Groundwater & Wastewater Services
Septic Project File & Data Review Worksheet

GWS File #: 7471B WASPS App #: 2972

SOIL/SITE EVALUATION
for ON-SITE WASTEWATER SYSTEM

GWS Septic System Design Review

Sketch of Soil Evaluation Locations

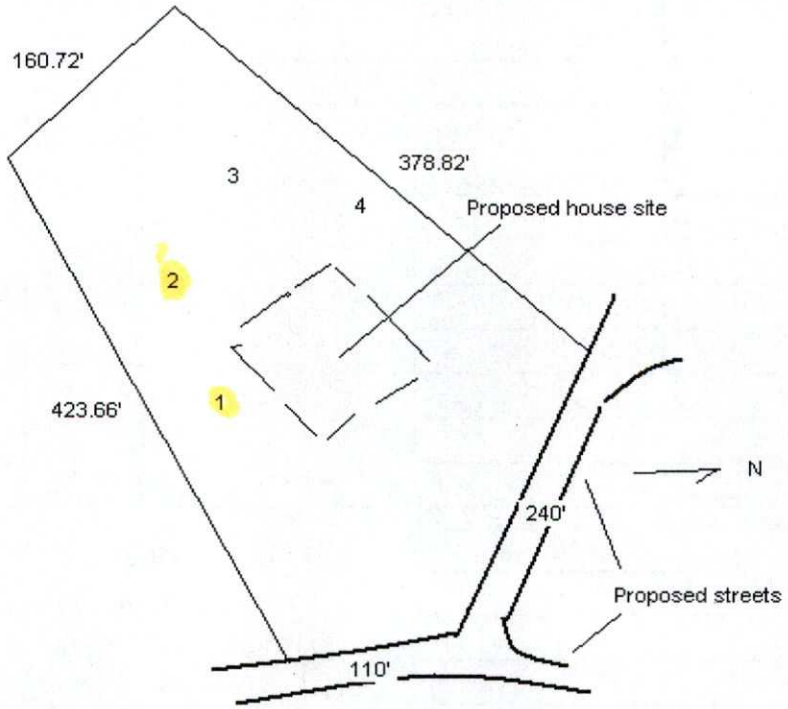
100% repair, disturbed area appears to be in small area, need drainfield areas to be spot-checked before permit is issued

Sketch of Soil Evaluation Locations

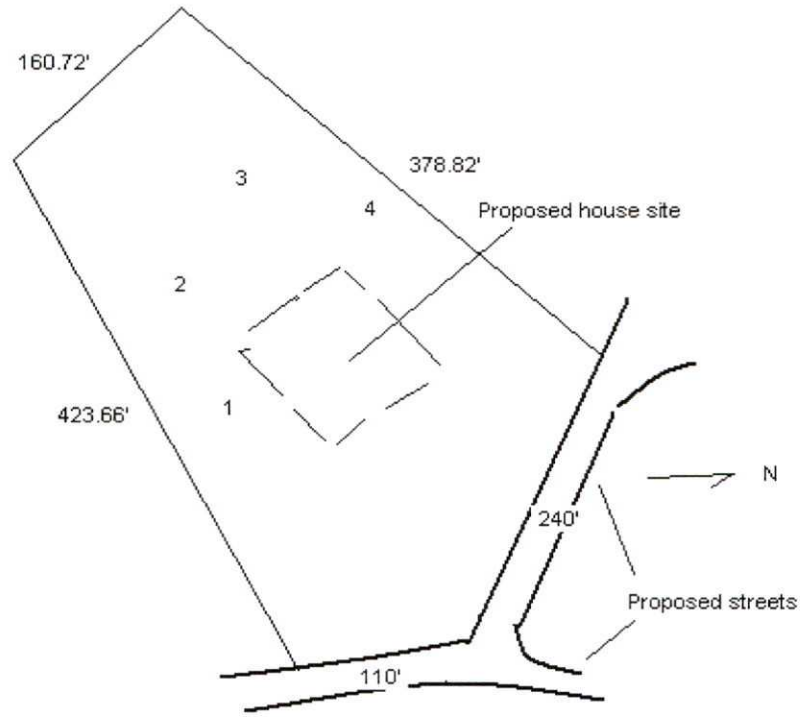
100% repair, disturbed area appears to be in small area, need drainfield areas to be spot-checked before permit is issued
